# Access Compliance Report

## Public Rights-of-Way

### (Curb Ramps)

Intersection ID: 31481	Main Street: FLAGLER_LN	Cross Street: ROLETTE_CT	Location: SW
ADA ID: 9B191FD232D3	Ramp Type: PerpDiag	Initial Pass/Fail: Fail	Overall Compliance: No
Severity Score: 33.75			
Codes/Mitigation Info/Possible Solution		Field Measurements/Component Compliance

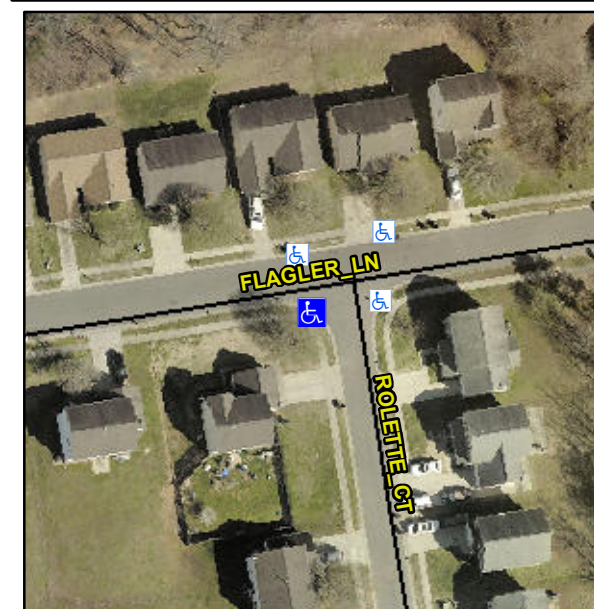
**Not Found, R304.5.1, R304.5.3**

Compliance	Description	Data	Compliance	Description	Data
N/A	Ramp Length (in)	47.5	Yes	Ramp Slope (%)	5.0
No	Ramp Width (in)	47.5	No	Ramp XSlope (%)	8.3
N/A	Flare Type LT	N/A	N/A	Flare Type RT	N/A
N/A	Flare Slope LT (%)	N/A	N/A	Flare Slope RT (%)	N/A
N/A	Flare Traversable LT?	N/A	N/A	Flare Traversable RT?	N/A
N/A	Landing Length (in)	N/A	N/A	DWS Provided?	N/A
N/A	Landing Width (in)	N/A	N/A	DWS Contrast?	N/A
N/A	Landing Slope (%)	N/A	N/A	DWS Length (in)	N/A
N/A	Landing X Slope (%)	N/A	N/A	DWS Full Width?	N/A
N/A	Landing Curb? (Y/N)	N/A	N/A	DWS Offset (in)	N/A
N/A	Shared Landing?	N/A			
N/A	Gutter Ponding?	N/A	N/A	Gutter Slope (%)	N/A
N/A	Gutter Lip Ht (in)	N/A	N/A	Gutter X Slope (%)	N/A
N/A	Painted X Walk1?	No	N/A	Painted X Walk2?	No
	X Walk 1 Direction	To E		X Walk 2 Direction	To N
N/A	X Walk 1 Width (in)	N/A	N/A	X Walk 2 Width (in)	N/A
	X Walk 1 Slope (%)	3.8		X Walk 2 Slope (%)	6.6
	X Walk 1 X Slope (%)	5.3		X Walk 2 X Slope (%)	5.5

**Remove & Replace Curb Ramp With Two New Directional Ramps or Equivalent.**
